Access Compliance Report

Public Rights-of-Way

(Curb Ramps)

Intersection ID: 10040591	Main Street: W_ARROWWOOD_RD	Cross Street: N/A	Location: NE
ADA ID: 29F067256210	Ramp Type: PerpDiag	Initial Pass/Fail: Fail	Overall Compliance: No
Codes/Mitigation Info/Possible Solution		Field Measurements/Component Compliance

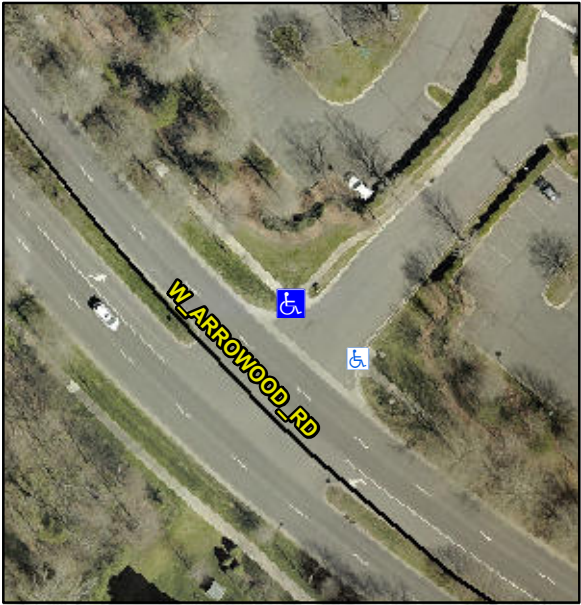
Possible Solutions:		Compliance	Description	Data	Compliance	Description	Data
	Remove & Replace Curb Ramp With Two New Directional Ramps or Equivalent.		N/A	Ramp Length (in)	57.0	No	Ramp Slope (%)	9.0
<p>Surveyor Notes:</p> <p>N/A</p>			Yes	Ramp Width (in)	50.5	No	Ramp XSlope (%)	2.5
			N/A	Flare Type LT	N/A	N/A	Flare Type RT	N/A
<p>PROW/ADA:</p> <p>R304.2.2, R304.5.3</p>			N/A	Flare Slope LT (%)	N/A	N/A	Flare Slope RT (%)	N/A
			N/A	Flare Traversable LT?	N/A	N/A	Flare Traversable RT?	N/A
<p>Total Cost:</p> <p>\$ 3200.00</p>			N/A	Landing Length (in)	N/A	N/A	DWS Provided?	N/A
			N/A	Landing Width (in)	N/A	N/A	DWS Contrast?	N/A
			N/A	Landing Slope (%)	N/A	N/A	DWS Length (in)	N/A
			N/A	Landing X Slope (%)	N/A	N/A	DWS Full Width?	N/A
			N/A	Landing Curb? (Y/N)	N/A	N/A	DWS Offset (in)	N/A
			N/A	Shared Landing?	N/A			
			N/A	Gutter Ponding?	N/A	N/A	Gutter Slope (%)	N/A
			N/A	Gutter Lip Ht (in)	N/A	N/A	Gutter X Slope (%)	N/A

N/A	Painted X Walk1?	No	N/A	Painted X Walk2?	No
				X Walk 1 Direction	To W		X Walk 2 Direction	To S
			N/A	X Walk 1 Width (in)	N/A	N/A	X Walk 2 Width (in)	N/A
				X Walk 1 Slope (%)	2.4		X Walk 2 Slope (%)	0.1
				X Walk 1 X Slope (%)	1.4		X Walk 2 X Slope (%)	2.5
			N/A	Ramp inside XWalk1?	N/A	N/A	Ramp inside XWalk2?	N/A
				Road Slope (%)	1.8	N/A	Clear Space?	N/A
				Road X Slope (%)	0.8	N/A	Clear Space to XWalk (in)	N/A
			N/A	Any Obstructions?	N/A	N/A	Storm Grate/Utility Hazard?	N/A
				Obstruction Type			Storm Grate/Utility Type	
						N/A		N/A
						Yes	Surface Condition? (G/P)	Good
